CENTERVILLE CITY PLANNING COMMISSION AGENDA

2. Administrative Decisions - The Hive Development 555 North 400 West

**CENTERVILLE
PLANNING COMMISSION
Staff Backup Report
2/24/2021**

A4 **DOUBLE DUMPSTER ENCLOSURE**
1/4" = 1'-0"

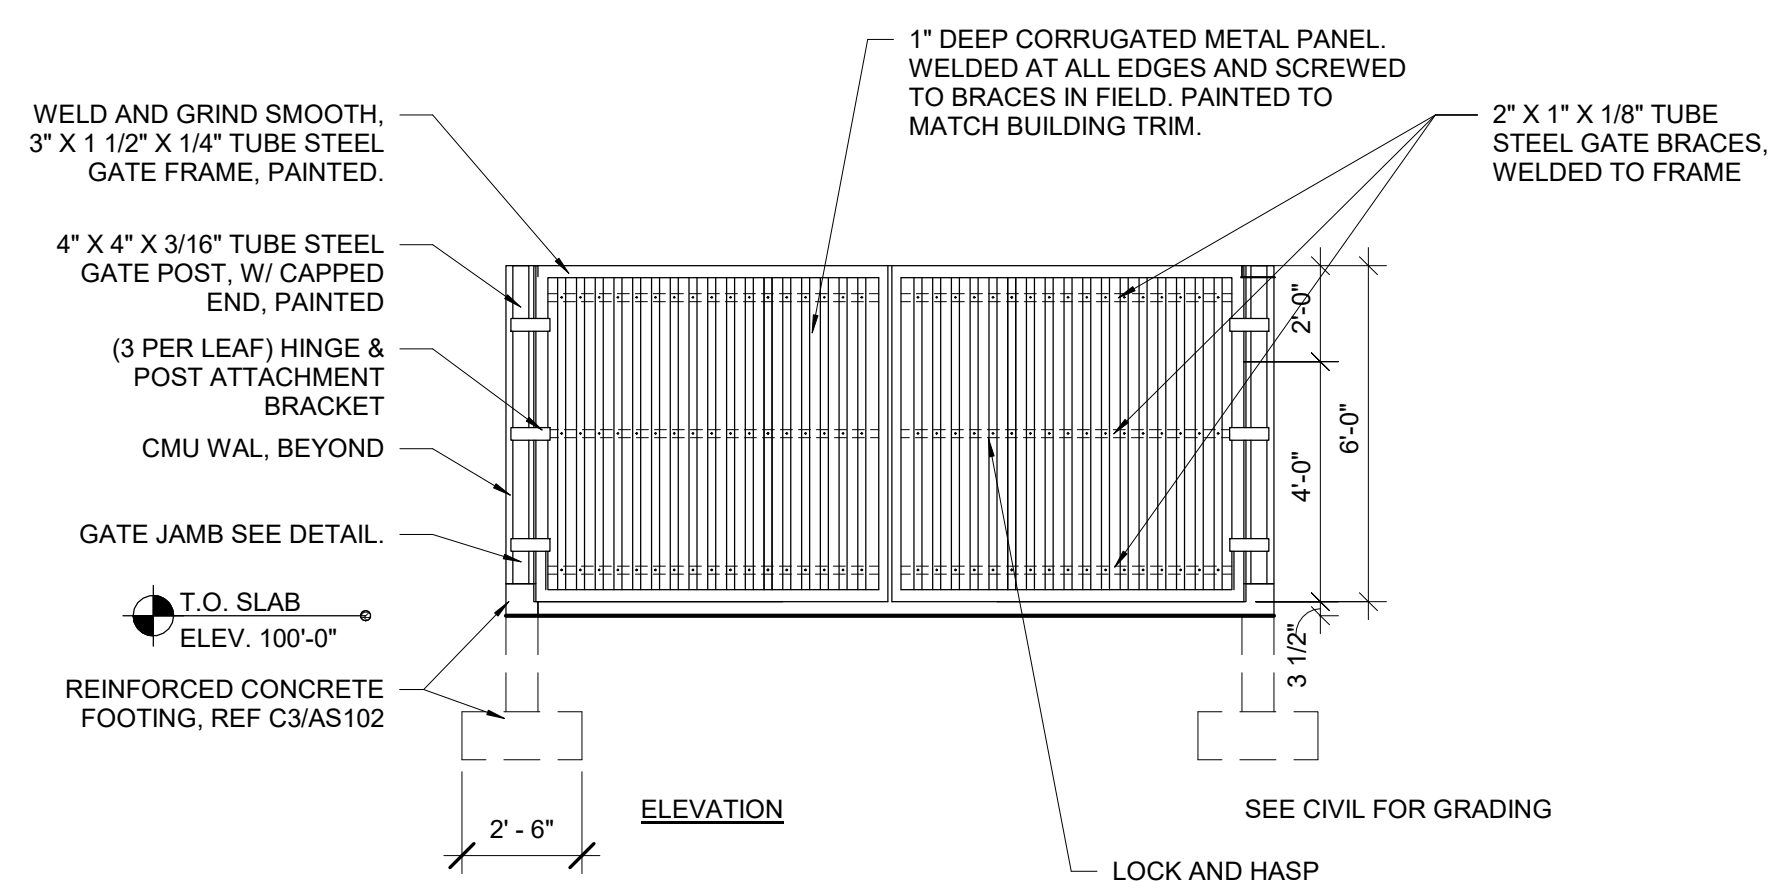
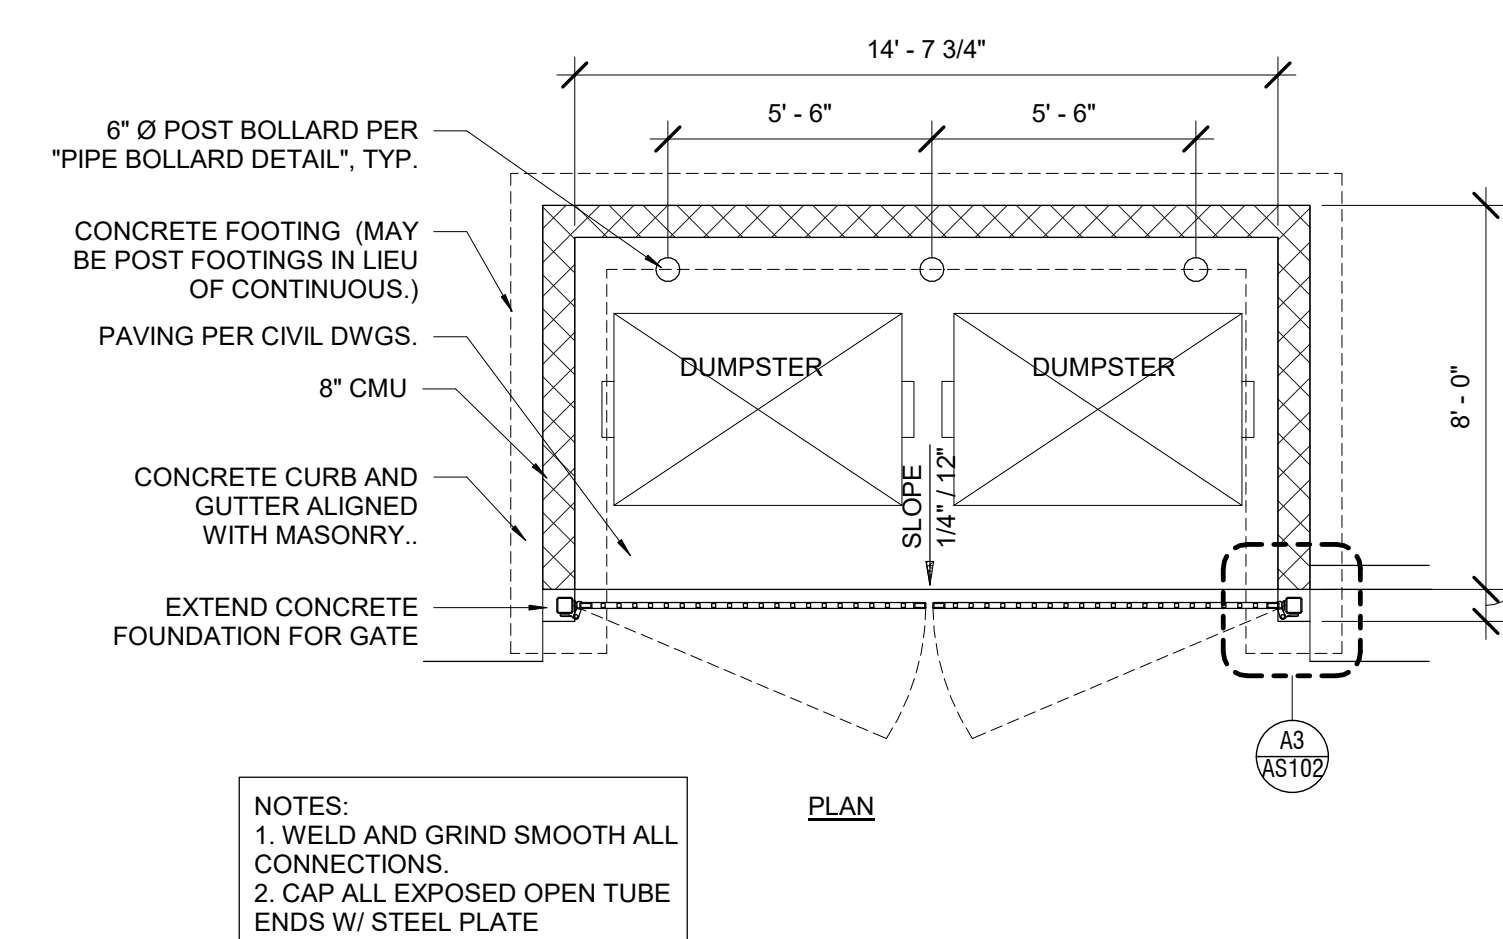
The plans do not show any detail concerning the trash enclosures. The dumpster must be completely screened from view with an opaque six-foot wall or fence. The wall or fence must be compatible in material and color of the main buildings on the site.

Solid Waste Disposal – For the residential portion of the project, we will work with the City's Public Works Department to develop a solid waste plan that utilizes the Black and Blue bins. Our CC&R's will include language on where cans are to be placed and limit the window that they can be on the street. Included with the office building, is our design for dumpster screening.

Single Family Exteriors

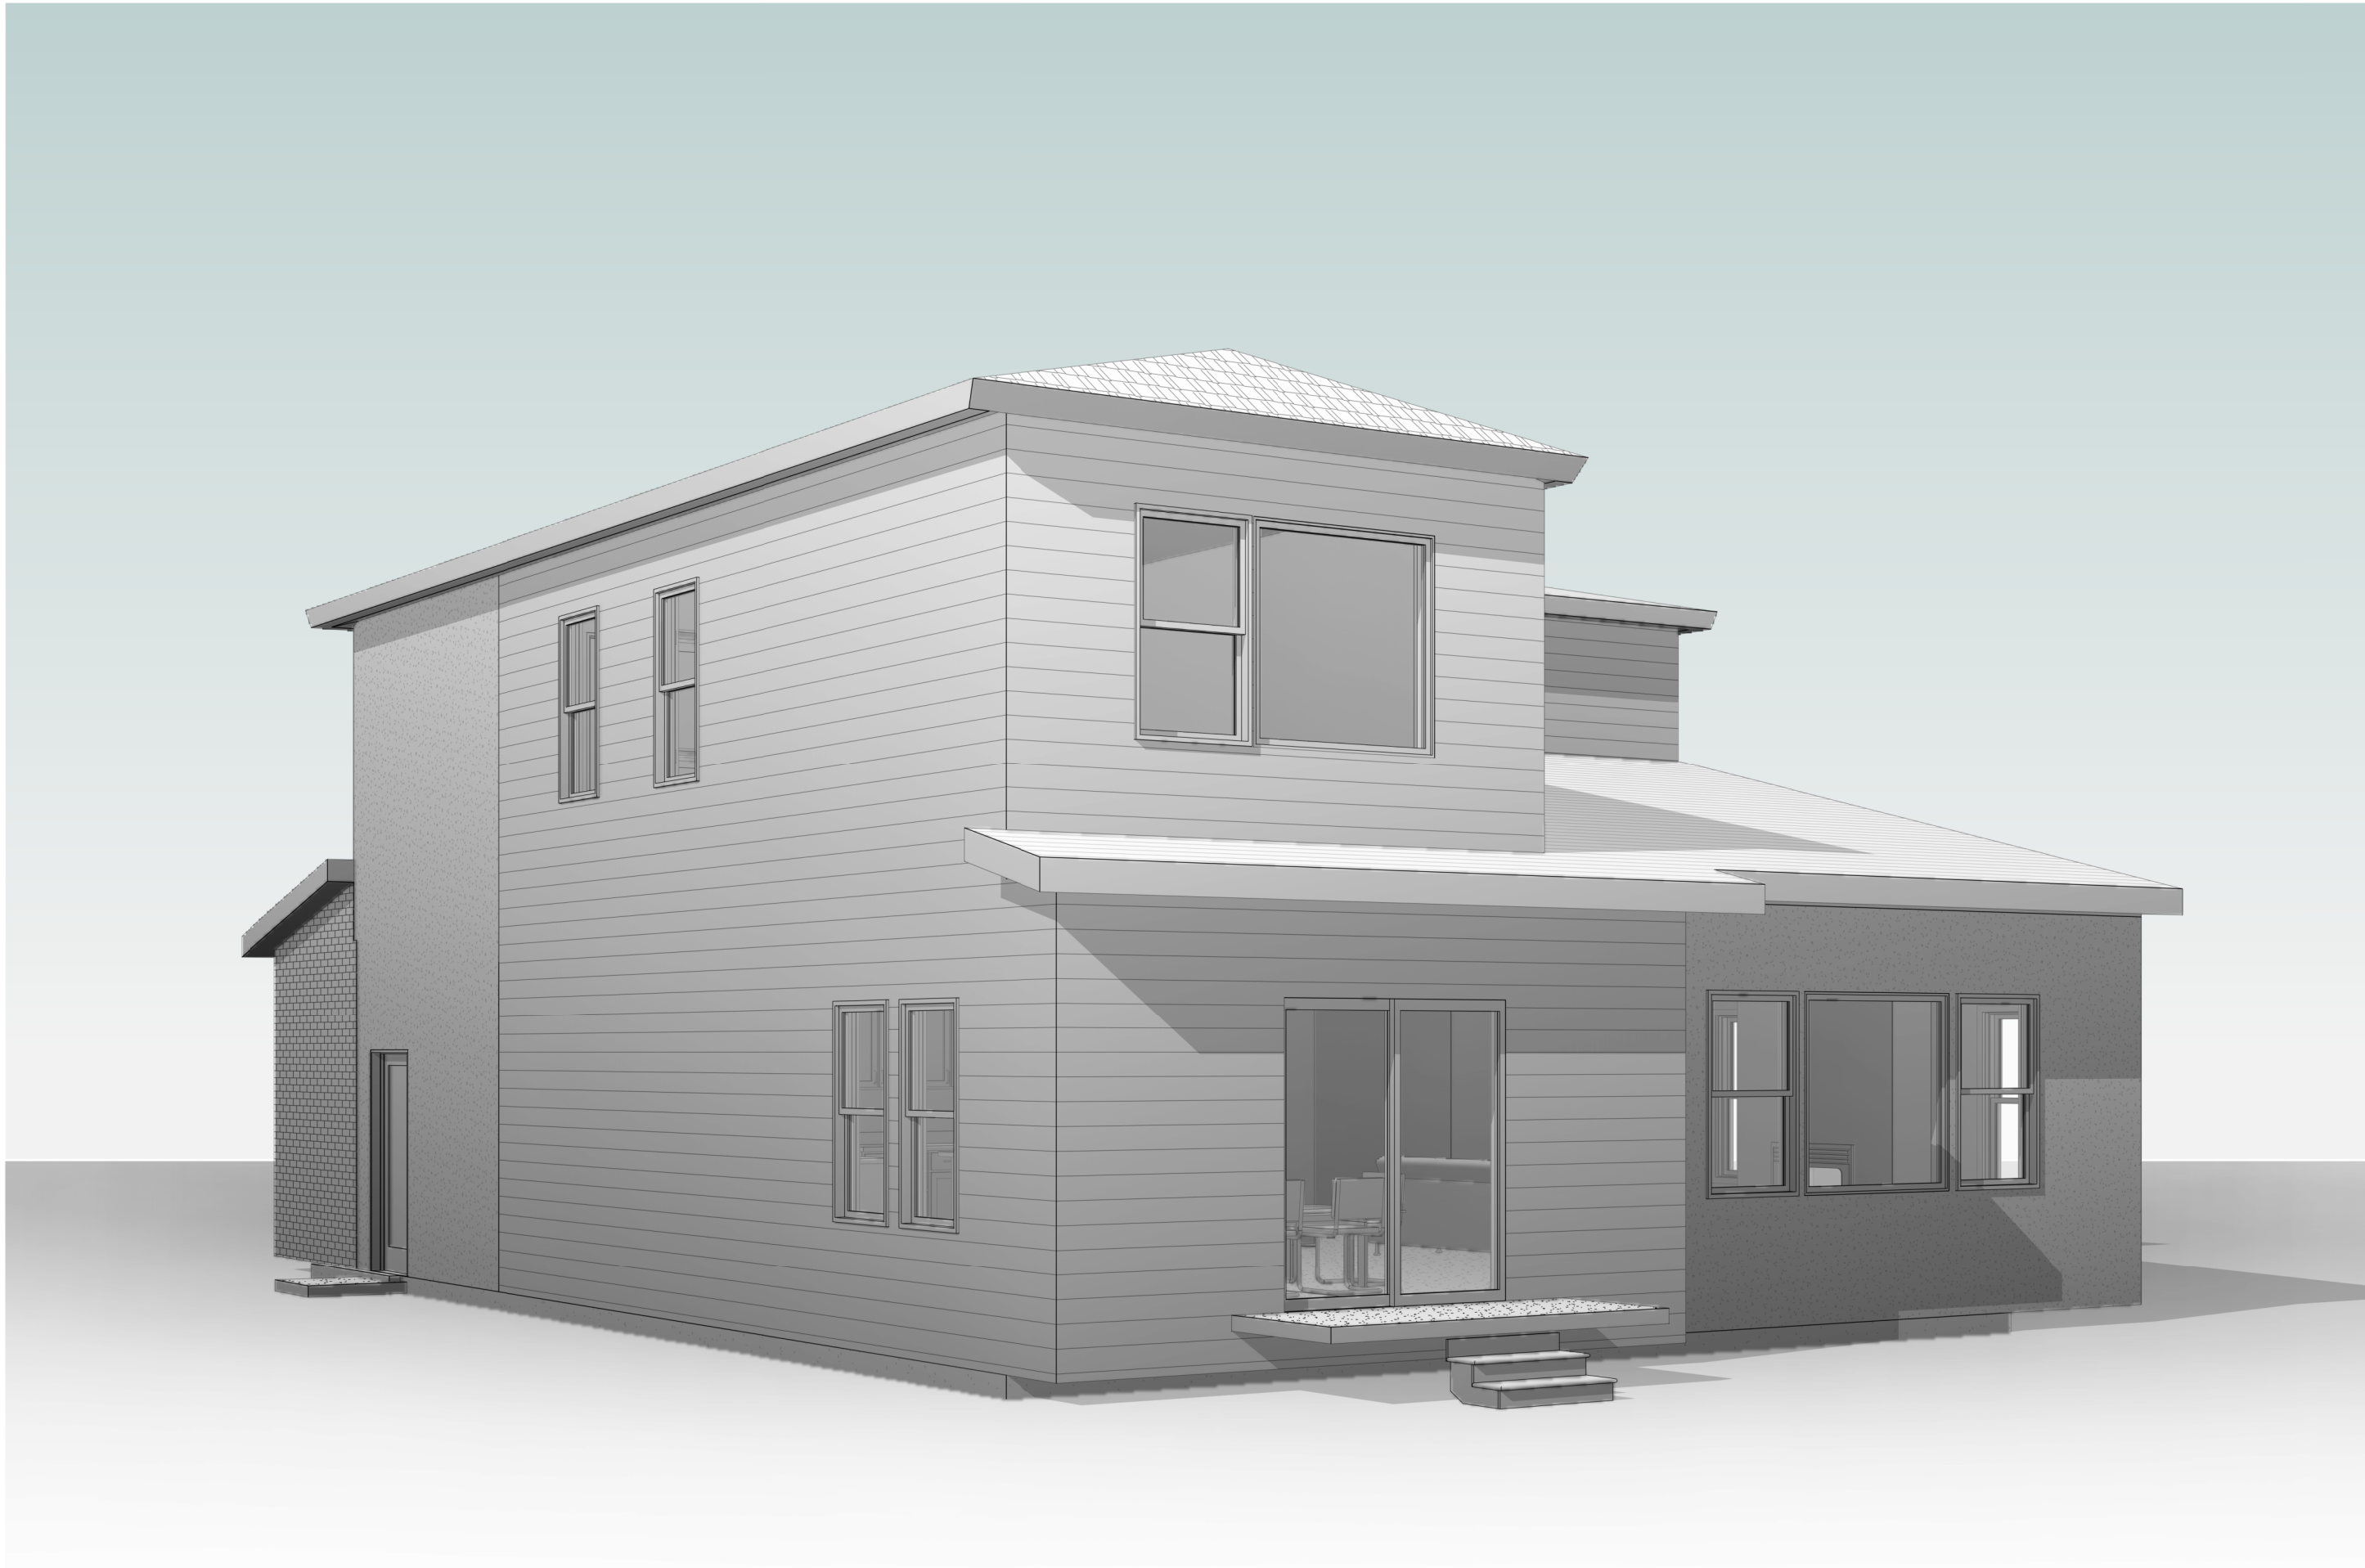
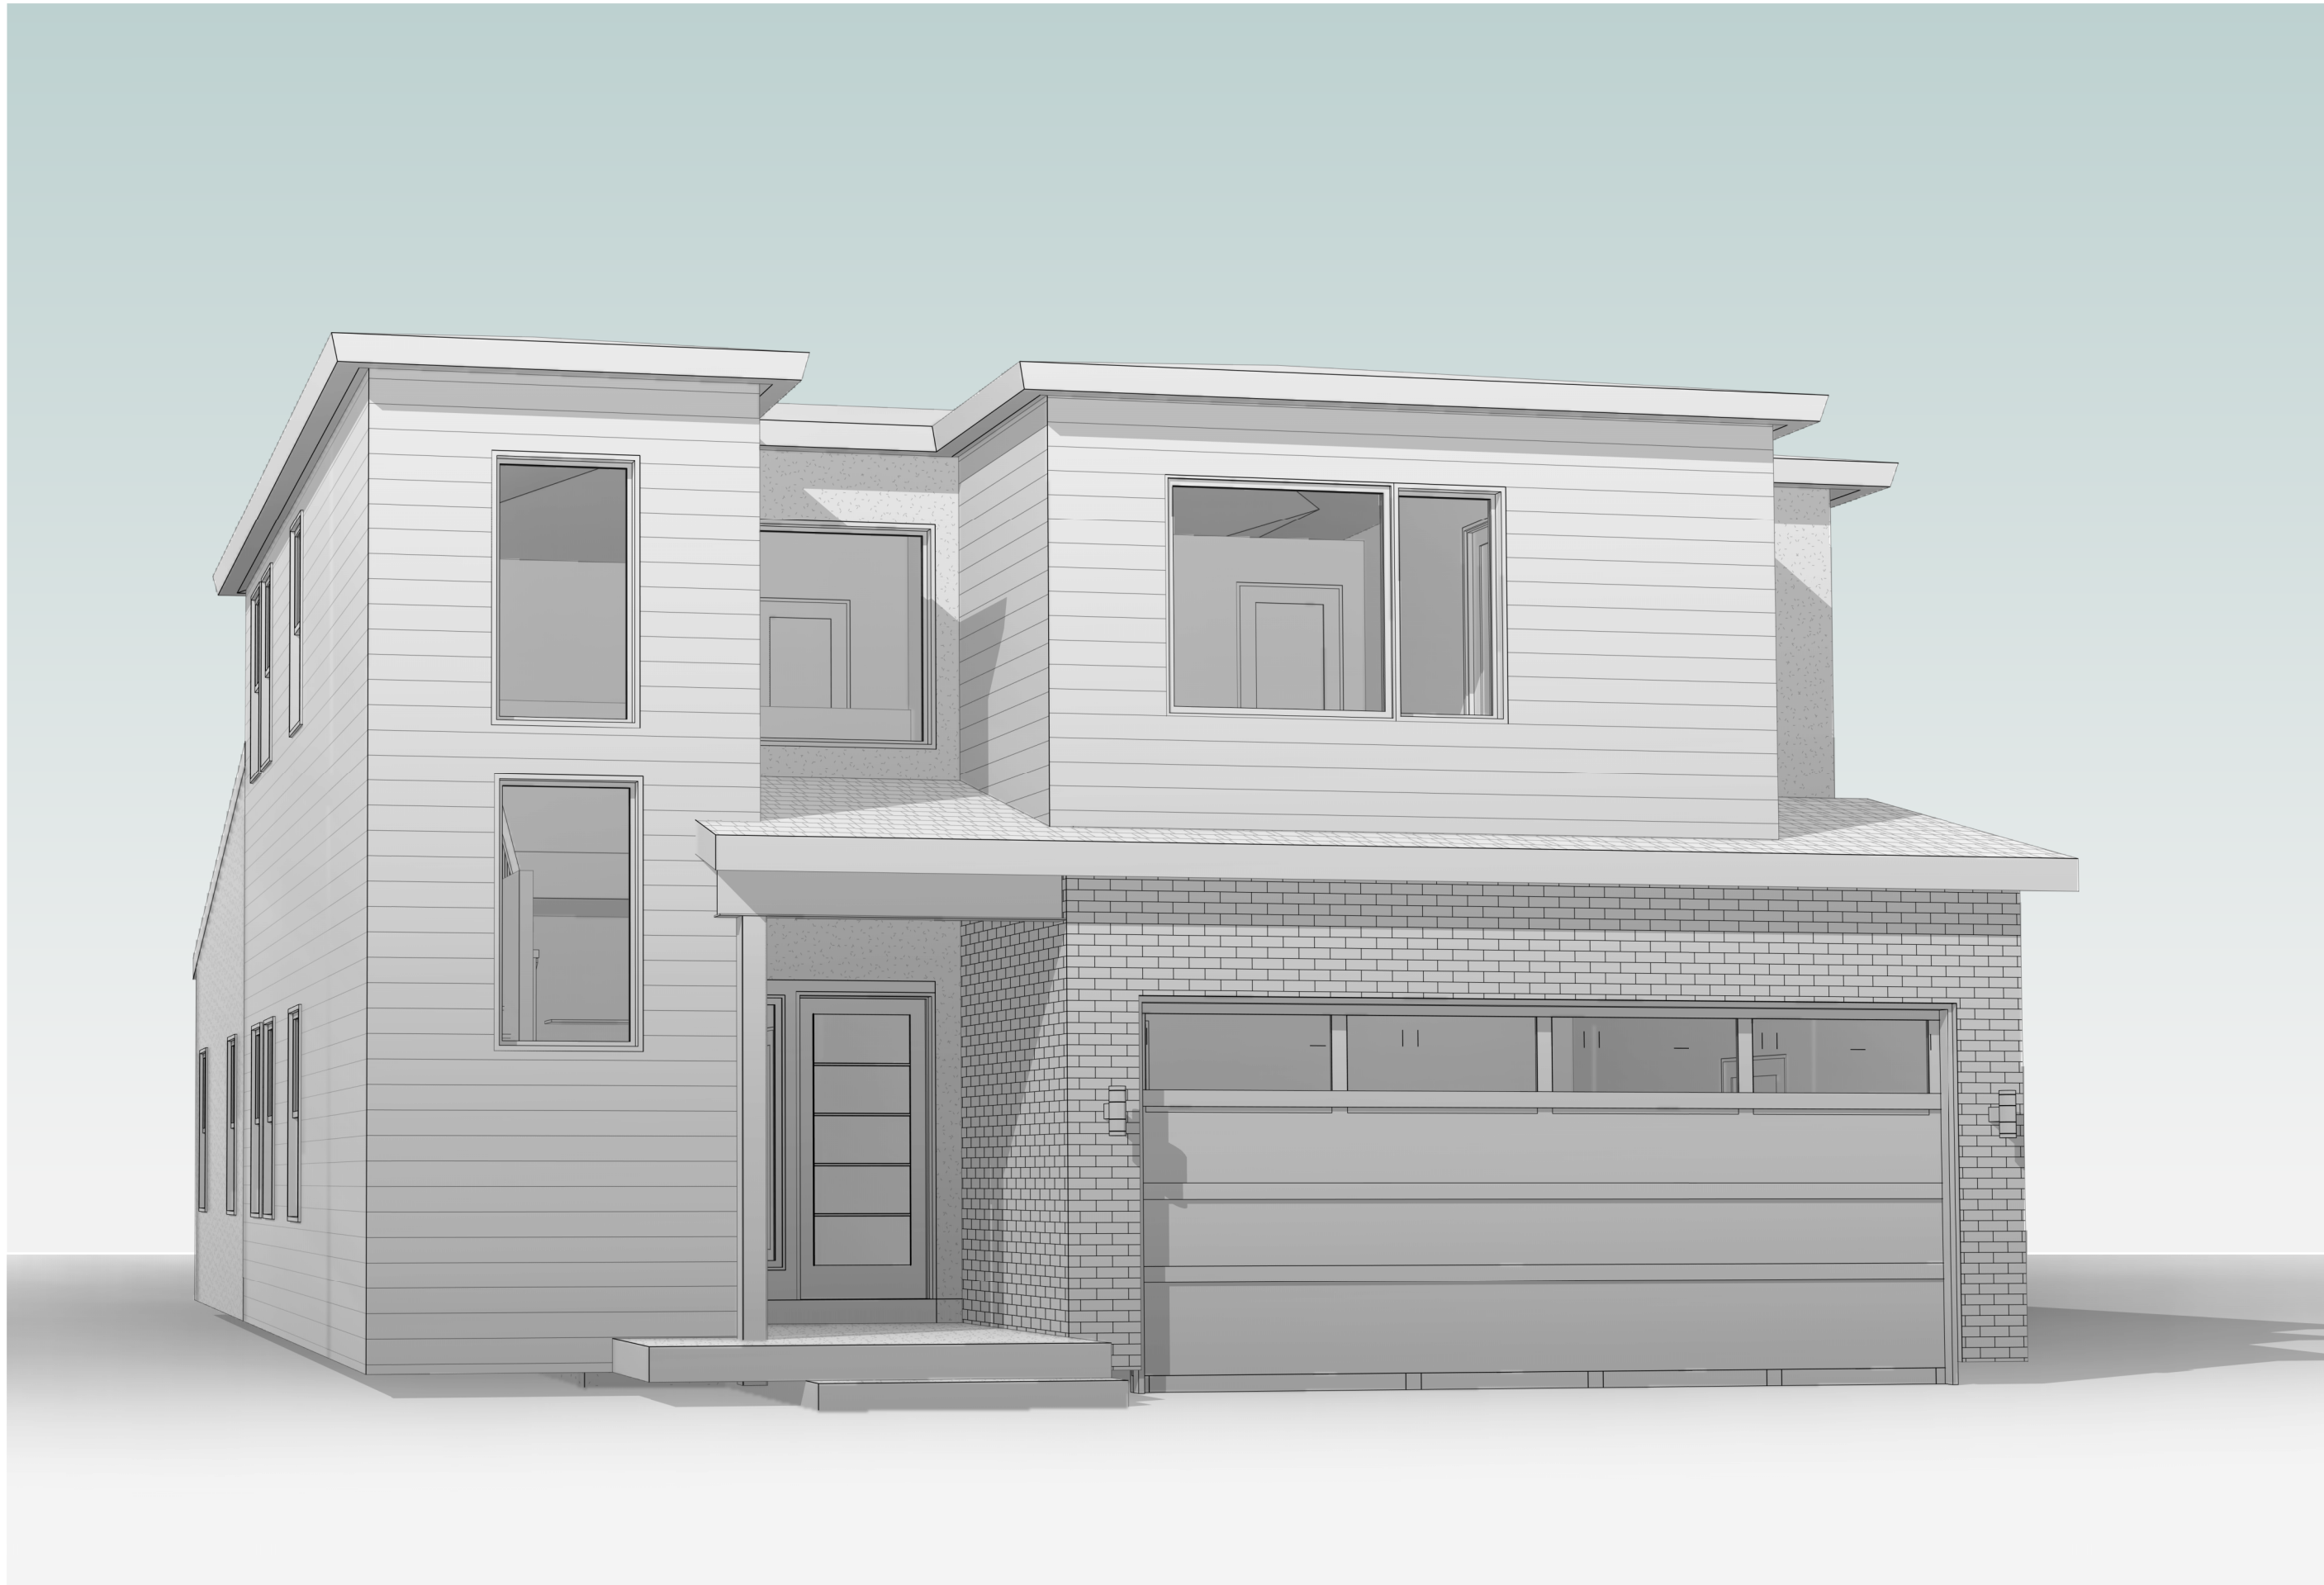
Residential Building Exterior Elevations – The Final Site Plan submittal **MAY OR MAY NOT FULLY COMPLY** with the expected PDO Approved Exterior Material Design, more specifically for the Single-family homes. The **expected SF building design and material appears to be altered** from what was approved in the PDO Approval. Nonetheless, applicant argues that the original designs were conceptual in scope and the final designs still incorporate and maintain the expected R-H Zone design standards and are significantly more cohesive to the over theme of the development.

Staff believes that new proposed SF designs are more consistent with the overall built theme of the development. The Planning Commission will need to determine if the altered designs significantly deviate to warrant an amendment to the PDO Approval. Here are the four (4) policy considerations.

Residential Building Elevations – As part of the PDO process, we submitted a rendering of one conceptual single-family home with 2 different facades. The conceptual renderings provided complied with the development standards of the applicable zone and were used as a tool to obtain approval of the PDO and illustrate the advantages of single-family homes in the project. The concept renderings attached to the PDO package were conceptual and not a fully developed plan. Upon approval of the PDO, we started to fully develop single-family plans. We determined we wanted to offer 3 distinct home plans to meet the needs of various buyers. We developed these plans with varying square footages and features, one being a master on the main floor. The fully developed single-family home plans are attached and, while their look and materials differ from the conceptual rendering previously presented, we do not believe the changes are substantial as they follow the development standards of the applicable zone and ultimately accomplish the same purpose. We feel the fully developed architecture for the single-family homes is more cohesive with the townhomes and commercial architecture and will significantly increase the curb appeal of the community. We request that our final site plan be approved with the new single-family architecture without a PDO amendment giving the changes are not substantial.
